Tennessee Valley Authority, Post Office Box 2000, Soddy-Daisy, Tennessee 37384-2000

TVA-SQN-TS-03-10

SEQUOYAH NUCLEAR PLANT (SQN) - UNITS 1 AND 2 - TECHNICAL SPECIFICATIONS (TS) CHANGE 03-10 - LICENSE AMENDMENT REQUEST (LAR) FOR THE SEISMIC QUALIFICATION OF THE MAIN CONTROL ROOM (MCR) AIR DELIVERY COMPONENTS AND SUSPENDED CEILING

TENNESSEE VALLEY AUTHORITY SEQUOYAH NUCLEAR PLANT (SQN) UNITS 1 AND 2

Proposed Revision to UFSAR Figure 9.4.1-1:

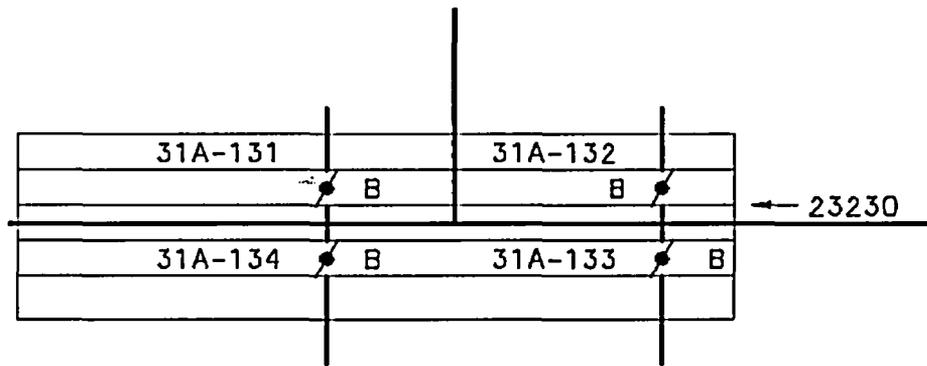
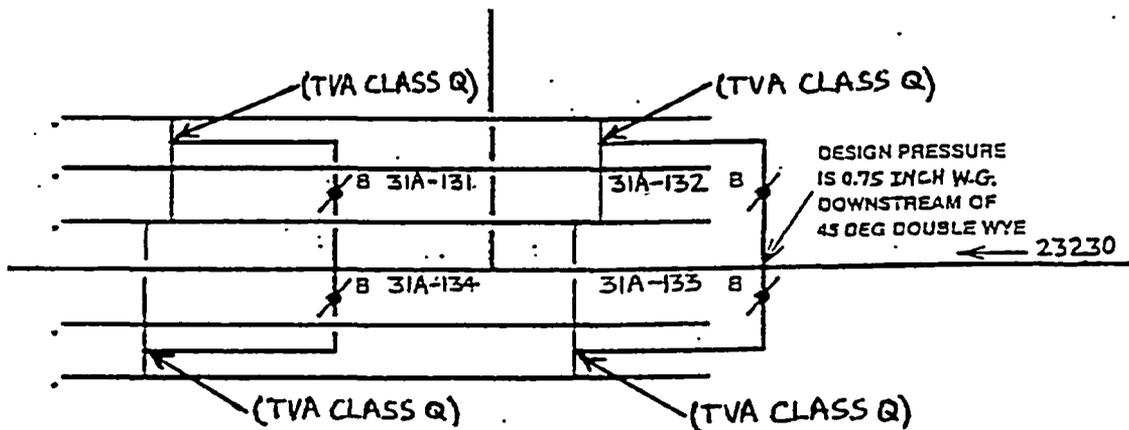
UFSAR Figure 9.4.1-1 is based on TVA Drawing 1,2-47W866-4. The current detail of the MCR HVAC system is depicted as follows on Drawing 1,2-47W866-4:

5 LINEAR DIFFUSERS

The proposed amendment replaces the above detail with the following information:

* 5 TRIANGULAR DUCTS WITH LINEAR DIFFUSERS :
